RE: OBSERVATION IN RESPECT OF A PLANNING APPLICATION FOR THE CONSTRUCTION OF A SINGLE STOREY DRIVE THROUGH COFFEE SHOP PAVILION DEVELOPMENT WITHIN THE EXISTING CARPARK OF LUCAN RETAIL PARK, BALLYDOWD, LUCAN, CO. DUBLIN

SOUTH DUBLIN COUNTY COUNCIL REG. REF. SD21A/0323

Figure 2.1: Proposed Elevations C and D

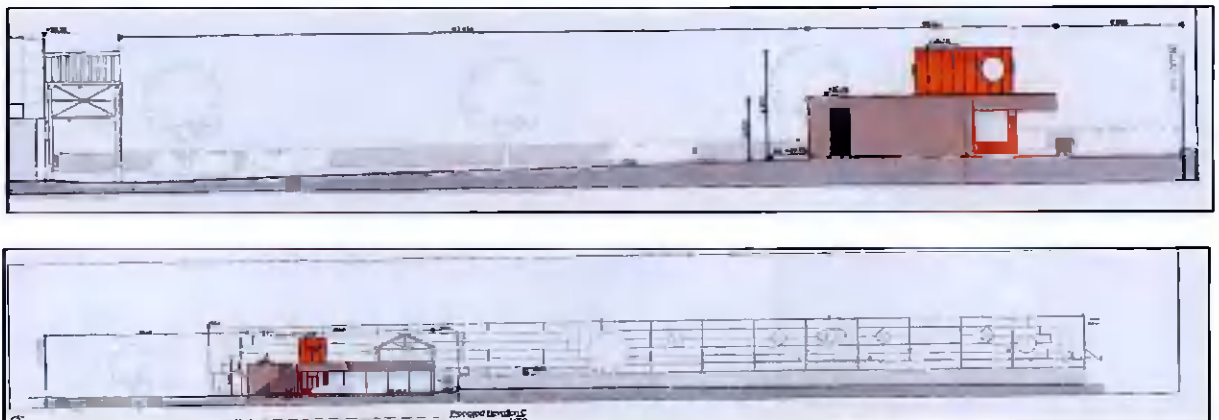
This observation thus solely pertains to the design of the unit as currently proposed and specifically the design of the large-scale roof box signage. Our Client is concerned at the scale of the signage box proposed to the roof of the building which is shown in elevations in Figure 2.1 below. Whilst the coffee shop is a single storey structure it is representative of a two storey structure due to the height of the signage box proposed above the parapet. The signage box element extends to a point that is just 1.48m below the existing Lucan Retail Park parapet.

In our opinion the elevations and CGI demonstrate that the roof signage box as proposed is excessively large (2.92 metres in height which is equivalent to a generous full floor level of development) for its position at the entrance point to the development and thus will constitute visual clutter.

Our Client is thus respectfully requesting that if the Planning Authority is minded to Grant Permission for the scheme that a condition be attached requiring the omission of the roof signage box and the provision of the signage on the fascia of the building, as is commonplace in similar coffeeshop pavilion developments (as outlined in Section 2.3).

Figure 2.2: CGI Image of Scheme from N4

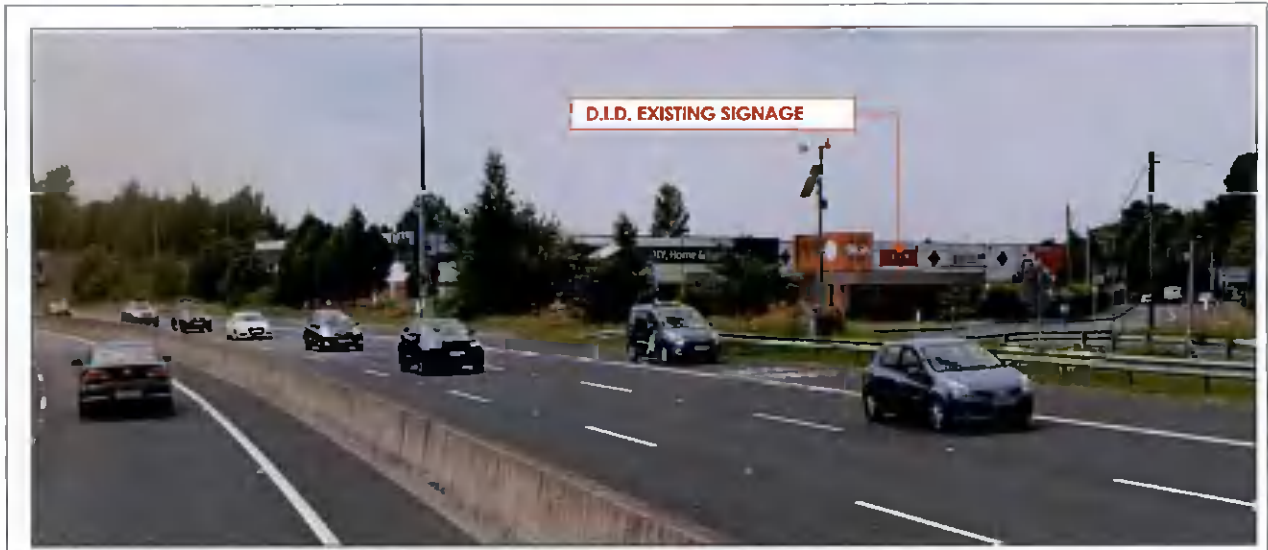
Our Client informally requested that the Applicant provide further detail of the Visual Impact of the scheme and was furnished with the image below from the Applicant team to depict the View of the scheme from the N4.
